| <b>REPORT TITLE:</b>                          | 165 – 167 Rosedale Road, St Ives   |
| <b>PROPOSAL (AS AMENDED):</b>                 | Demolition of existing dwellings, erection of 2 x 5 storey residential flat buildings containing 51 units, basement carparking and associated landscaping works.   |
| <b>DEVELOPMENT APPLICATION N<sup>o</sup>:</b> | DA0408/10  |
| <b>RECOMMENDATION:</b>                        | Refusal  |

*Figure 1: Sight line blocked*

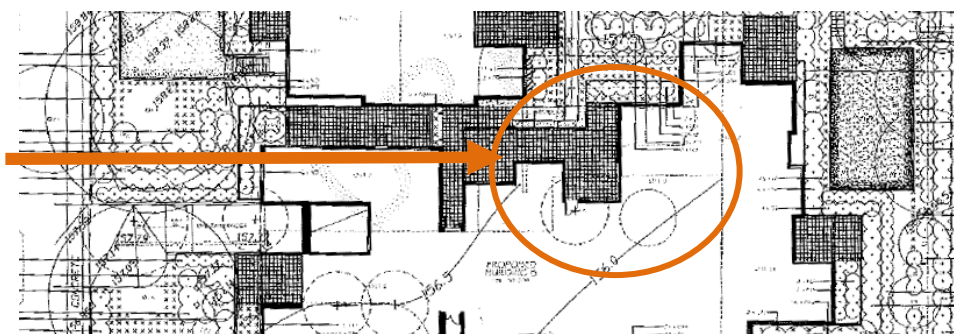
*The original development presented as two buildings that front Rosedale Road. The northern most building is approximately 32m in length and the southern building is about 17m in length and returns back along the southern boundary. The two buildings were separated by 3.0-3.5m.*

*The narrow gap between the two buildings would be improved if the gap provided a view through to a courtyard and was not obstructed by the south-eastern part of the building.*

*Building A and B have now been separated by 12 metres in compliance with Council's DCP. This provides better access to the site, improved solar access and better sight lines from the street into the rear of the site.*

*Figure 2: Original proposal - Areas of the building that overshadow other apartments. Floor area could be relocated to the area shown with the blue rectangle.*

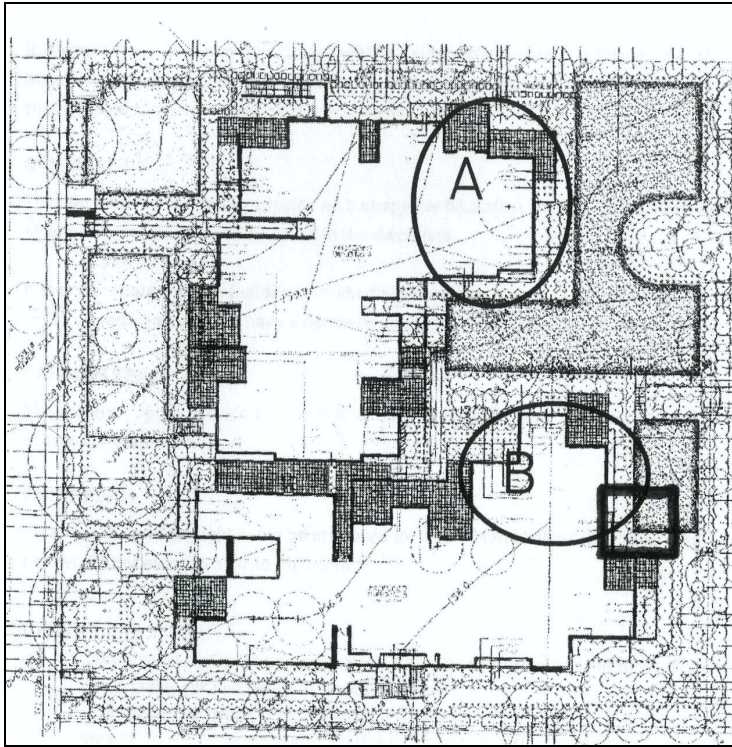
*With regard to the original proposal, it is unfortunate that the two 'legs' shown highlighted in **Figure 2** (below) result in the overshadowing of other apartments and the open space within the development. In particular the area marked B results in the overshadowing of unit 42 (and below) and begins to enclose the courtyard space unnecessarily.*

*It is noted that the setback to the eastern boundary is only 9m. Extending the building further to the east (with only a 6m setback) and removing the northern extension would be a more appropriate solution, however this should not be at the expense of increased overshadowing of 28A Shinfield and should be well set back from the southern boundary. This is shown in **Figure 2**.*

- *The privacy screen to Bed 1 in Unit 39 (and in a similar location below) is not considered necessary.*
- *Amendments to the area marked B in Figure 2 may result in the privacy screen to unit 39 (and below) not being necessary.*
